Tracey Saxby
Executive Director,
My Sea To Sky

July 26, 2025

In response to your request for a review of the validity of conclusions in the July 21, 2025 NHC memo titled, "*Henriette Dam Breach Impacts Assessment*" this document provides my comments.

Figure A) Approximate floatel locations added to NHC Figure 22

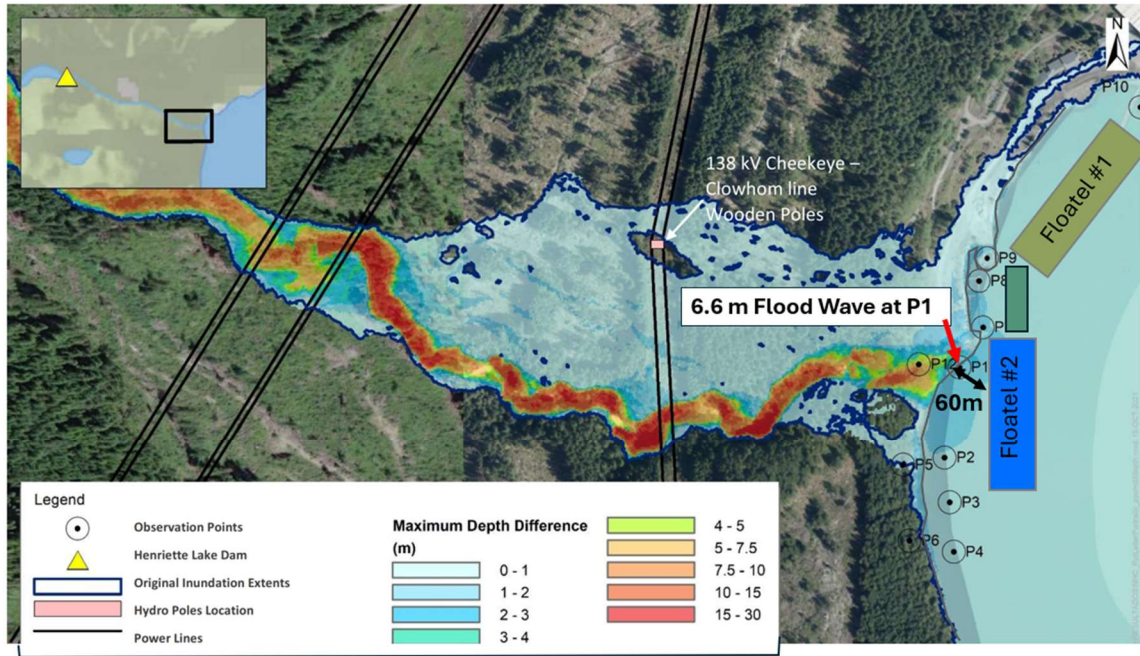
It seems unlikely that a flood impact wave of over 6 m in height arriving at the foreshore at over 12 m/s would only generate an impact wave of 0.5 at the Floatel #2 location directly offshore of 60 m from Woodfibre Creek. The reason for the low wave heights predicted in Table 3.1 of the memo is rather obvious upon looking at the locations of the modelled points as seen in Figures A and B.

Due to the above factors the predicted (actually "interpolated" using a questionable methodology) 0.5 m high impact wave height at 75 m downstream of P1 (the Floatel #2 centreline location) does not seem at all realistic. Especially considering that the Floatel #2 location is directly in front of the mouth of Woodfibre Creek which at P1 will experience a fast moving 6 m high wall of water in the event of a dam breach. It is not clear how "interpolating" in a direction perpendicular to the wave propagation has any physical significance for estimating wave height. The modelling did not actually include attenuation of wave heights to the closest location of the Floatel #2, instead the comment about "rapid attenuation" is an interpretation based on questionable assumptions.

The hazard assessment memo also does not consider potential effects of a debris flow which could mobilize large woody debris (telephone pole or larger size logs) at high speeds towards any infrastructure associated with the Floatel#2 installation. Floatel #2 would be directly inline with Woodfibre Creek. A debris flow could occur either concurrent with a dam break or simply as the result of heavy rainfall.

To substantiate an assessment of impact wave hazards at Floatel #2 will require actual modelling at the Floatel #2 location directly opposite Woodfibre Creek. This modelling would need to be done with both full wave equation modelling at sufficiently discrete time steps to resolve free surface wave effects and would need to incorporate directional impulse/momentum considerations.

Figure B) Wave Propagation Directions and “Interpolation Points” added to NHC Figure 2.1

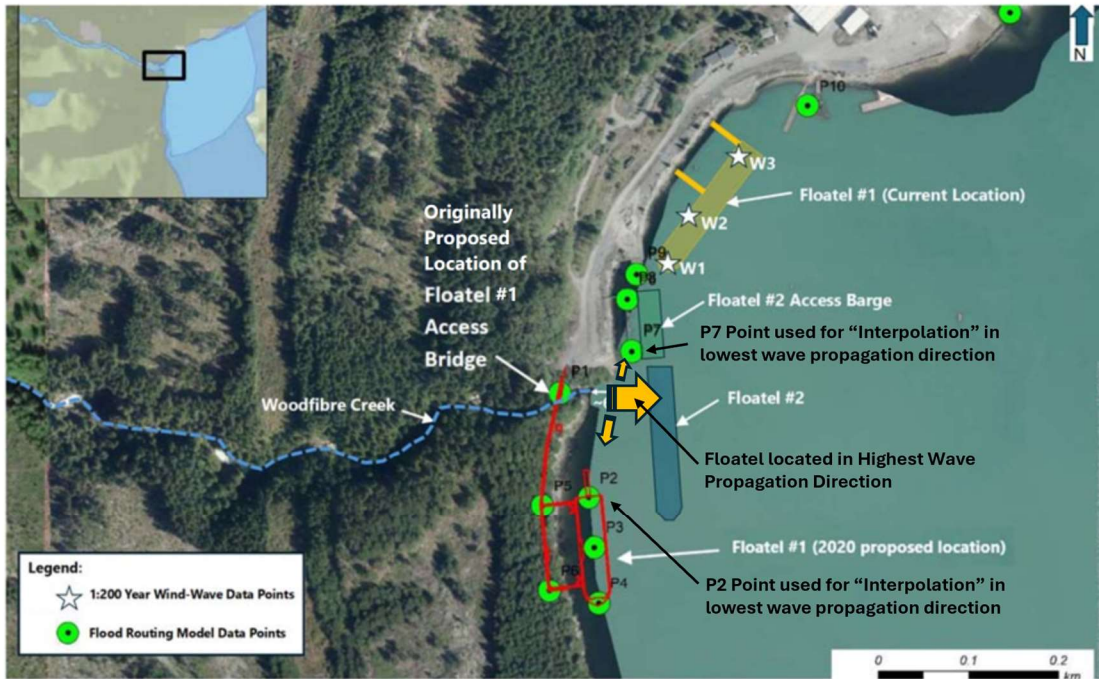
The memo also states that there was no actual modelling done at the location of Floatel #2 and that results were simply interpolated. However, the interpolation was based on results from propagation directions that are inappropriate for assessing wave heights at the closest point of Floatel #2 to the creek which is in the direction of maximum wave propagation. There is no information presented in the memo as to how this "interpolation" was done.

The quoted wave height value of 0.9 m in NHC's Table 3.1 is for point P2 located in the ocean near the shoreline, about 100 m south of Woodfibre Creek. A key point is that this location is perpendicular to the flood wave momentum direction. As a result, very little if any wave propagation is expected in this direction compared to the direct 60 m path to Floatel #2 - at which location impact wave height was not modelled.

Similarly, point P7 although closer to Woodfibre Creek is in the perpendicular direction to the north of the creek and is also behind the curve of the shoreline. So again, the modelled wave height of 1.2 m at P7 would be expected to be significantly lower than the actual wave heights at the directly exposed Floatel #2 location. So, two points of reduced wave height were selected for interpolation.
